RE: PETITION NO. 1416- Bloom Energy Corporation petition for a declaratory ruling, pursuant to Connecticut General Statutes §4-176 and §16-50k, for the proposed construction, maintenance and operation of a 150-kilowatt customer-side fuel cell facility and associated equipment to be located at the Home Depot, 89 Interstate Park Drive, Southington, Connecticut.

Petition No. 1416
Bloom Energy Corporation
Home Depot, 89 Interstate Park Drive
Southington, Connecticut

Interrogatories – Set I

DETAILED SITE PLAN

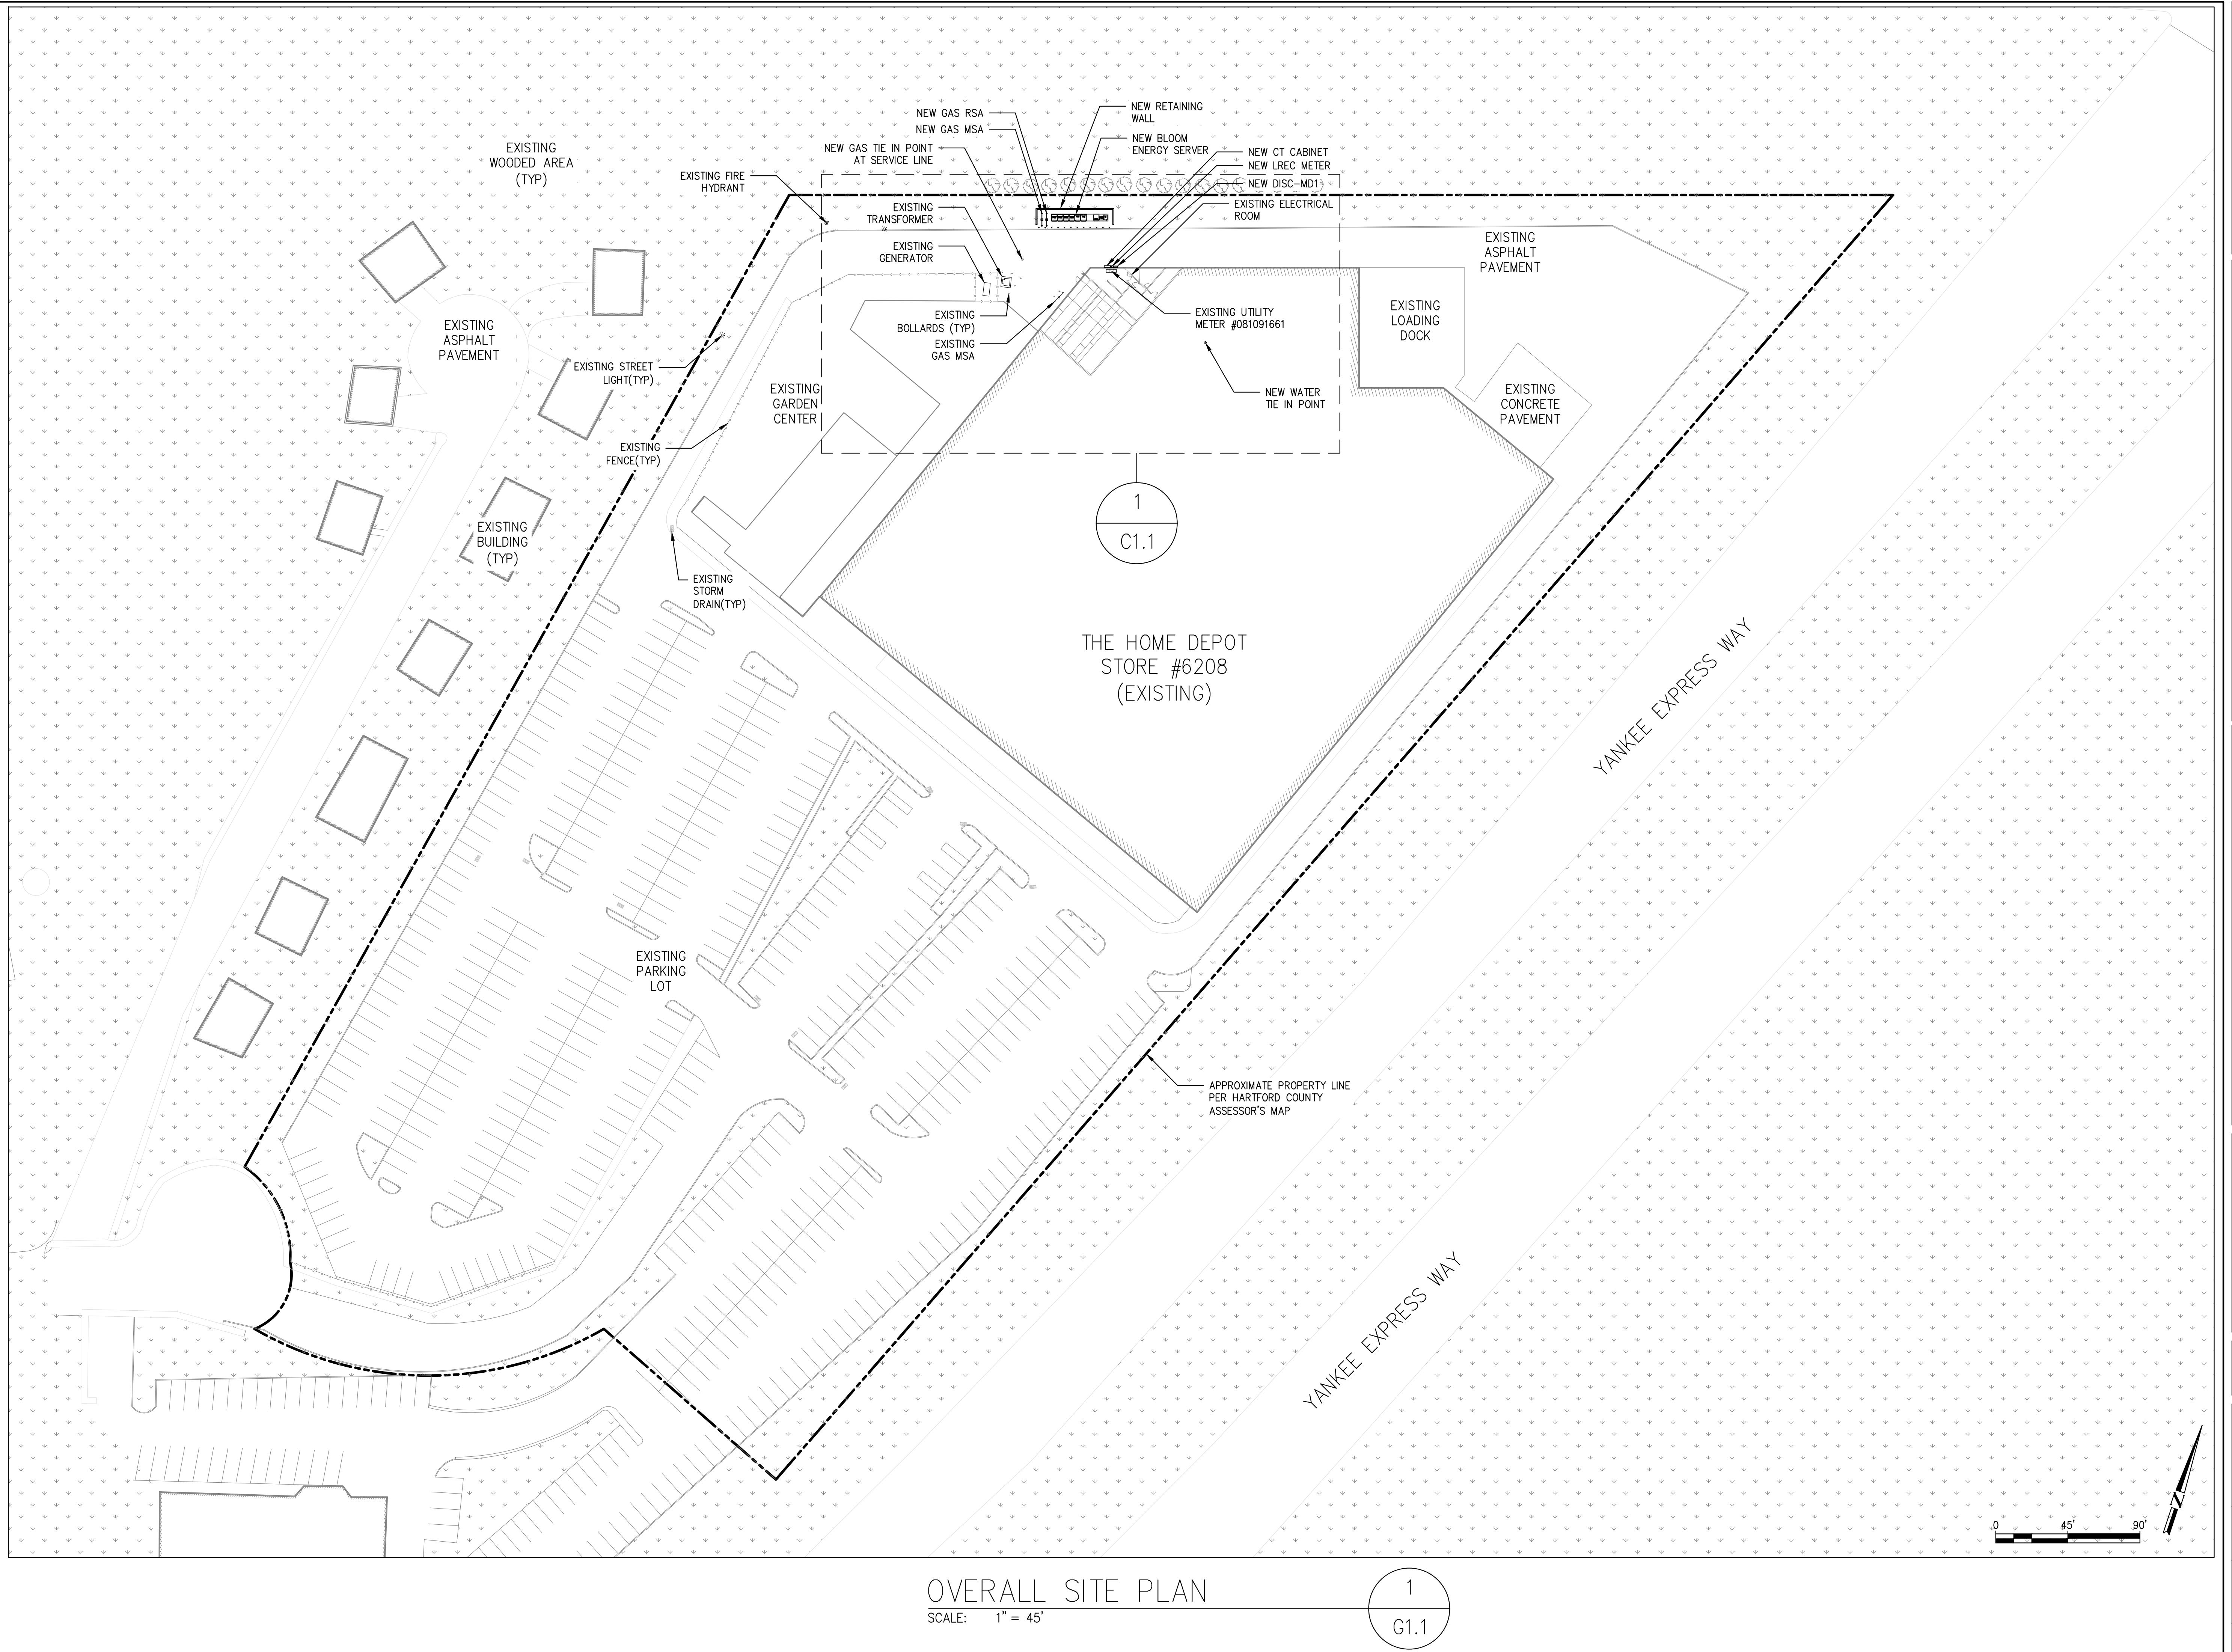
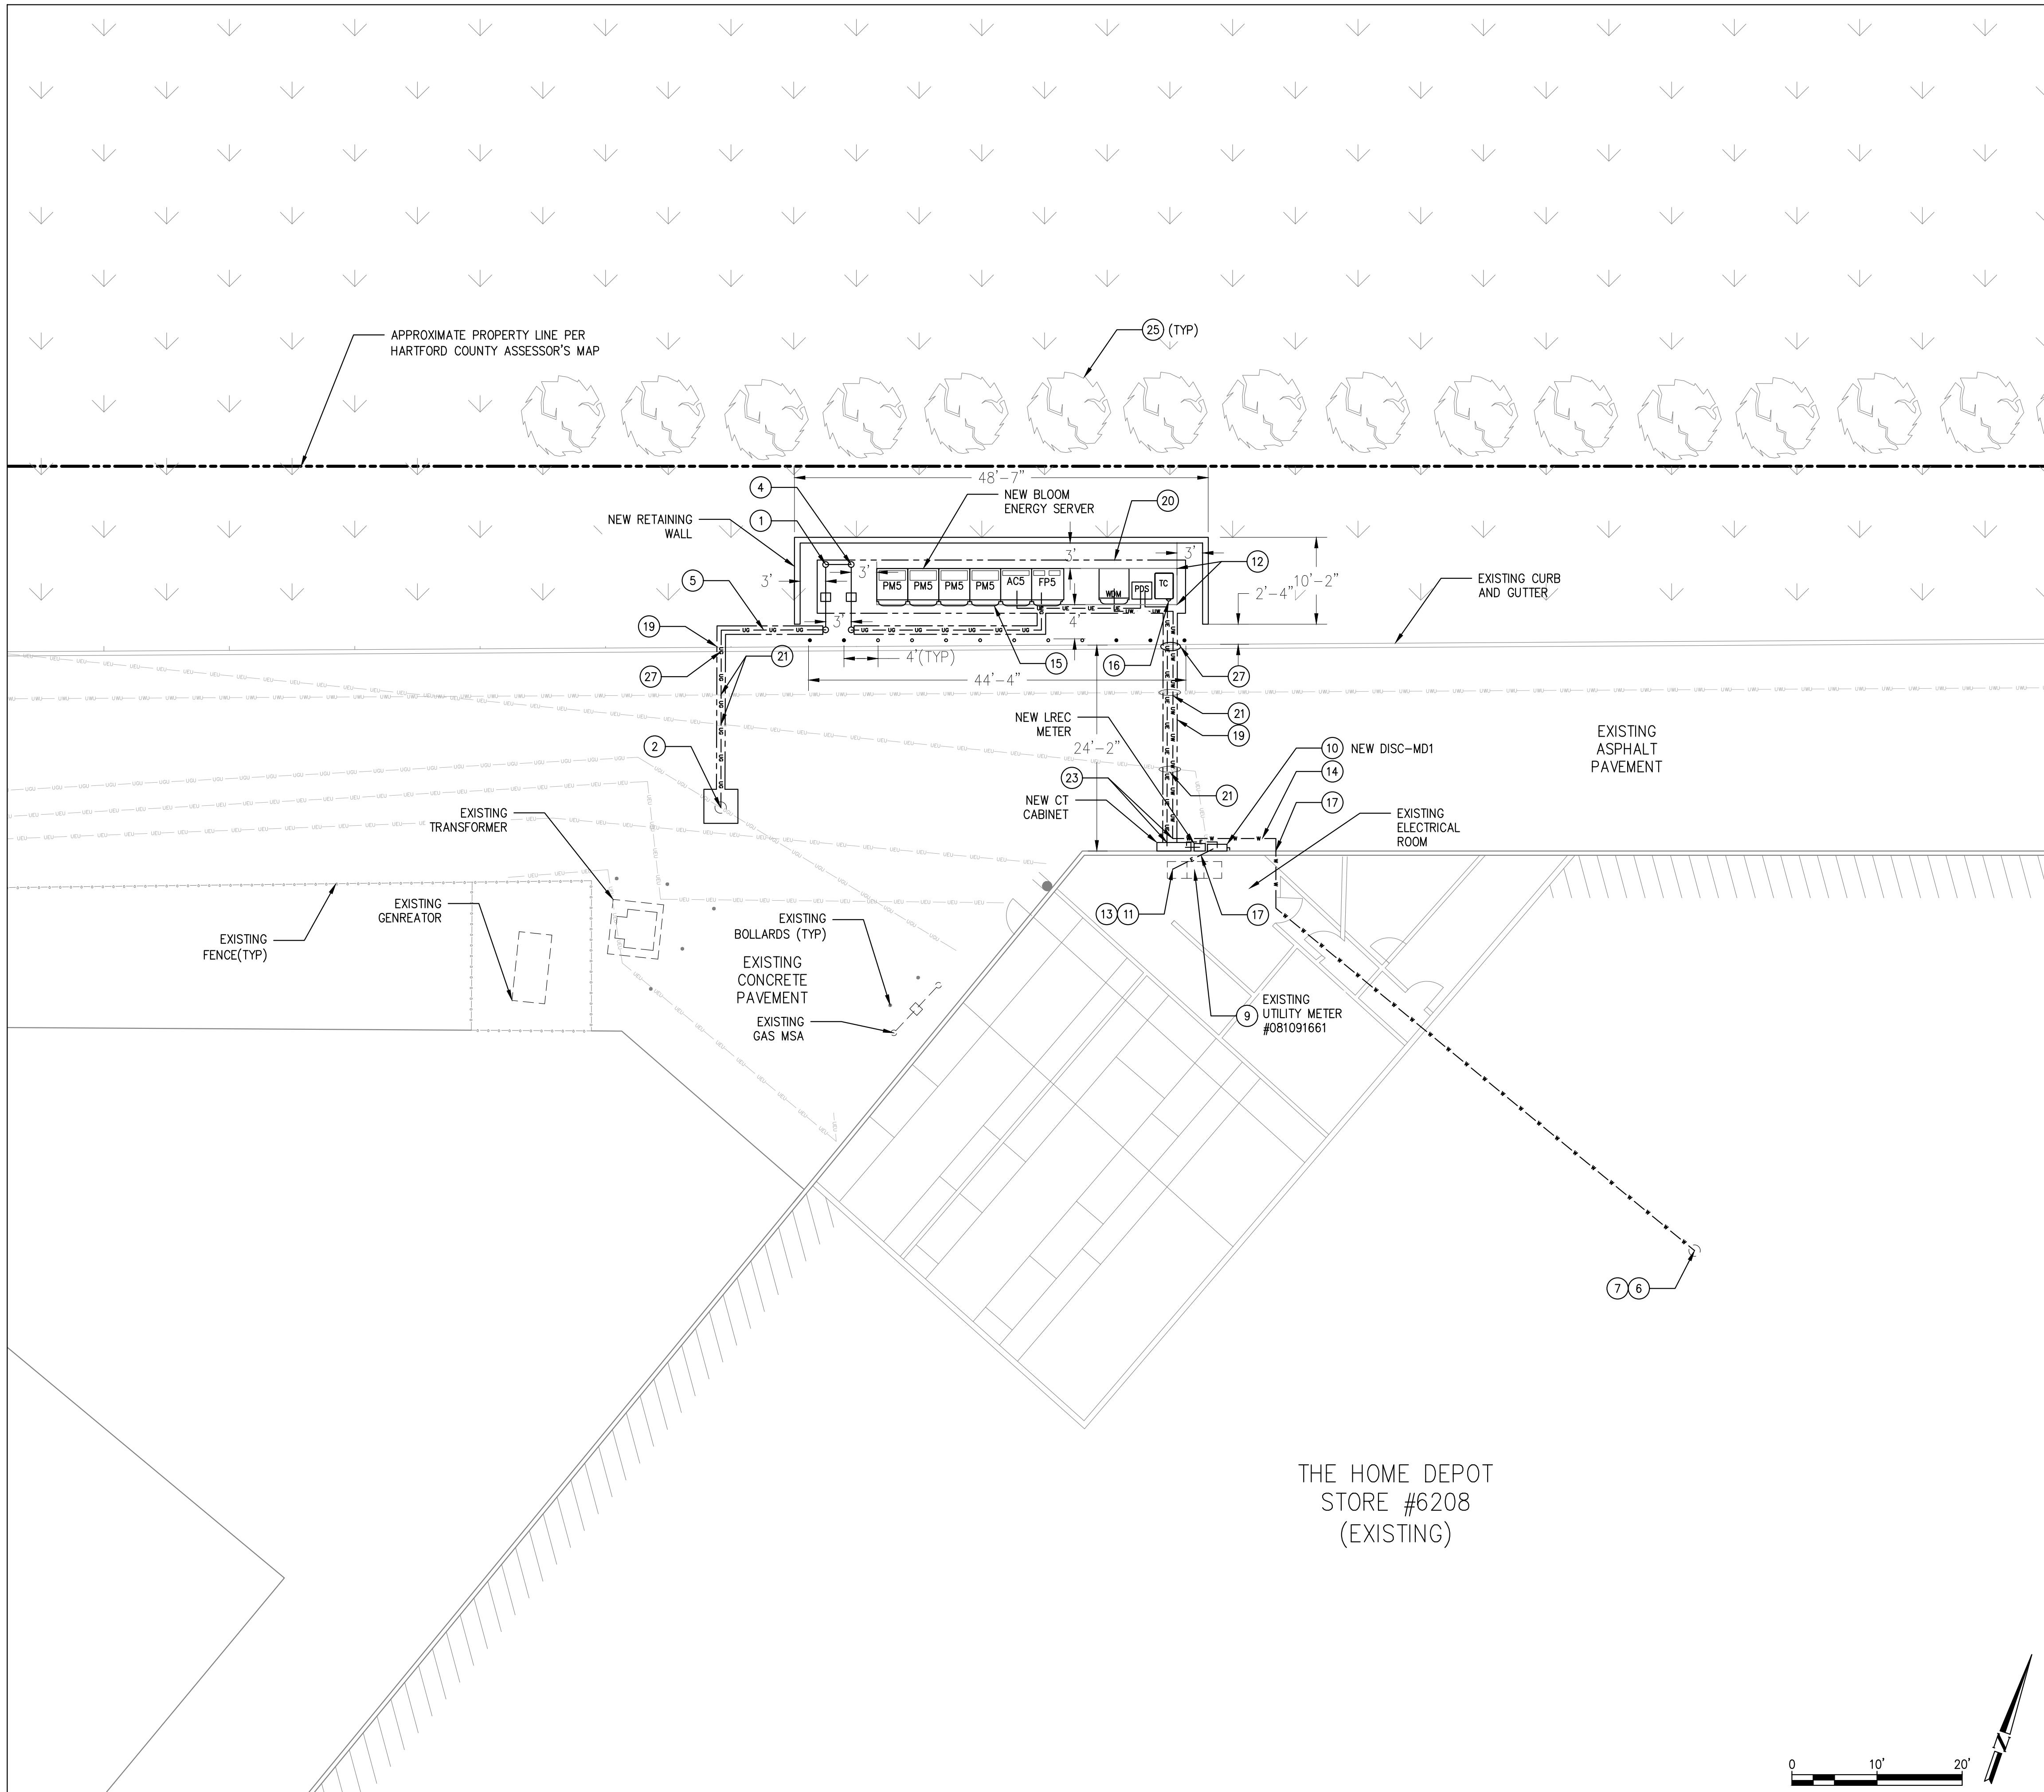
1. Please provide a detailed Site Plan of the proposed facility, including but not limited to, the dimensions and locations of the proposed fuel cell facility, concrete pads, cabinets, fence design, bollards (if applicable) and utility connections.

Response: Please see the attached site plan with dimensions and locations of the proposed fuel cell facility, concrete pads, cabinets, fence design, bollards and utility connections.
